## Groundwater Application Review Summary Form

Application # G- 18403

GW Reviewer Phil Marcy Date Review Completed: 4/27/2017

SUBJECT: Scenic Waterway Interference Evaluation

Water-Level Trends in Nearby Wells

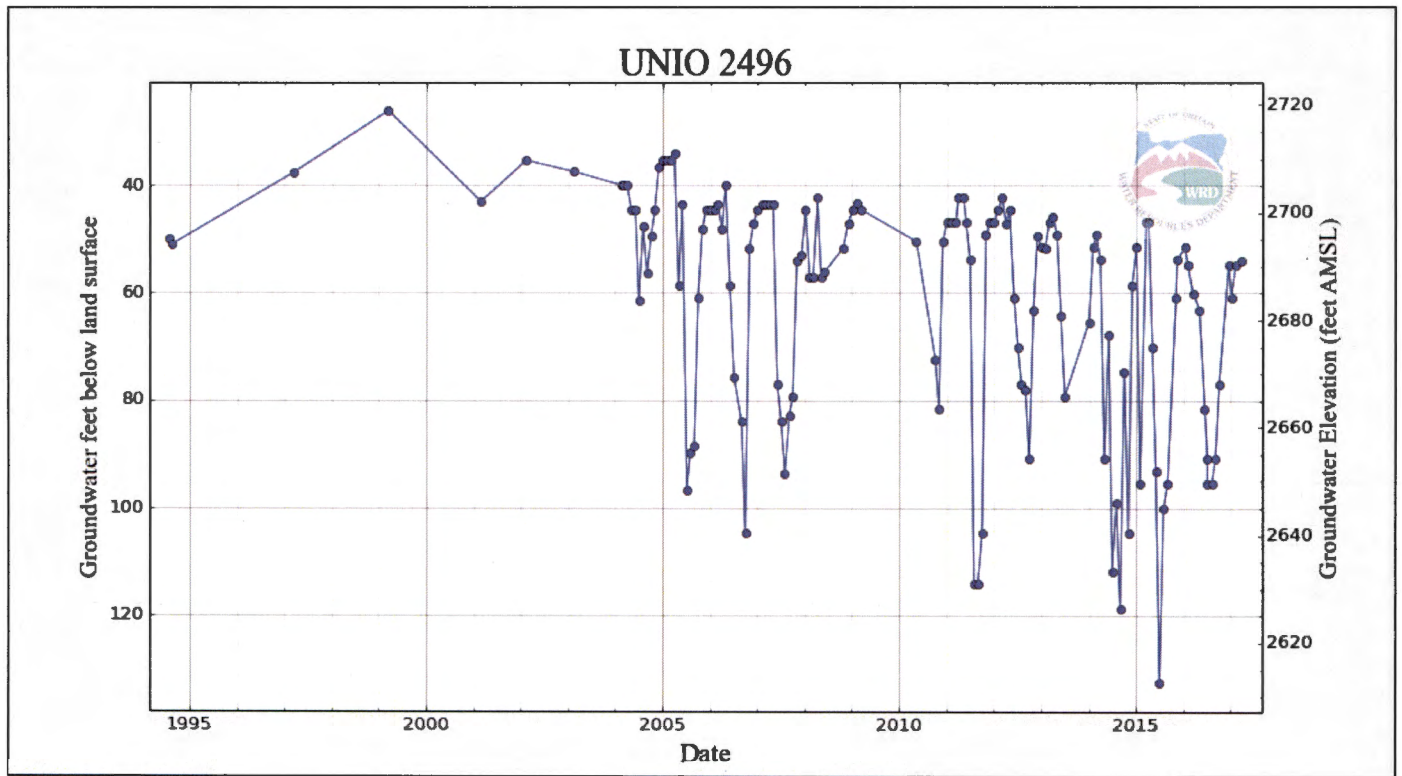
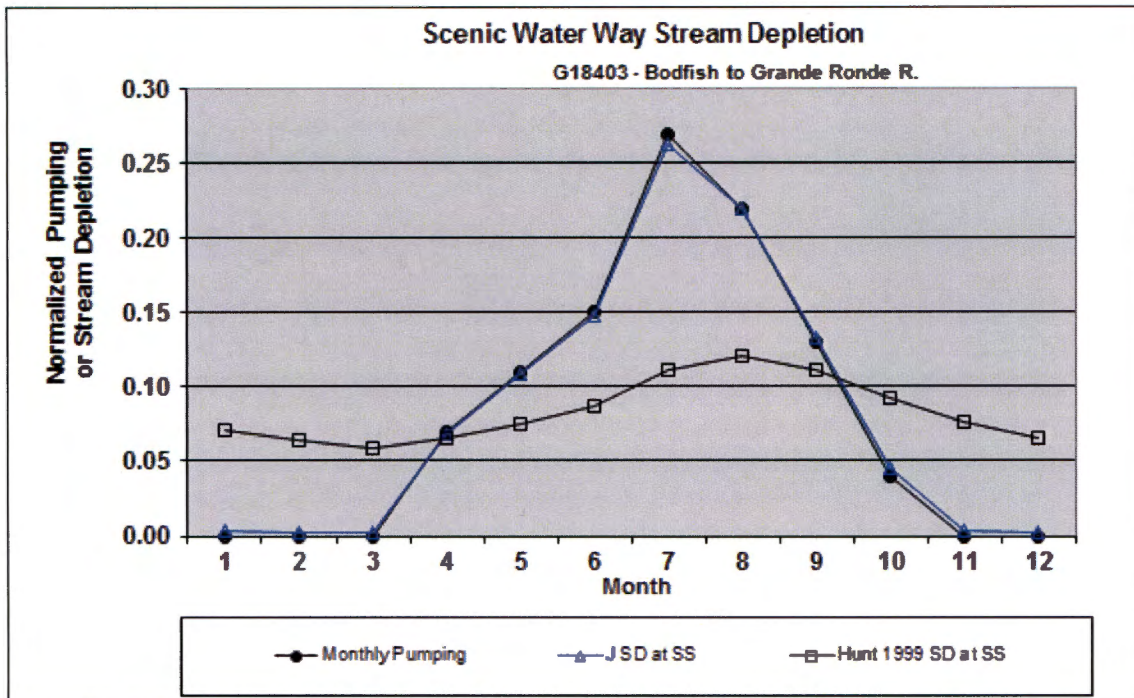
B3. **Groundwater availability remarks:** Nearby observation well, located less than 1 mile to the SE of the proposed POA location shows declines of greater than 10 feet within the past decade. These two wells produce from similar depths within the valley fill alluvial sequence and increased volume of pumping may cause more rapid drawdowns within this system. If a permit is issued, condition 7N is recommended to provide the Department with ongoing data, and if declines become severe, shut off or curtail production from the POA well.
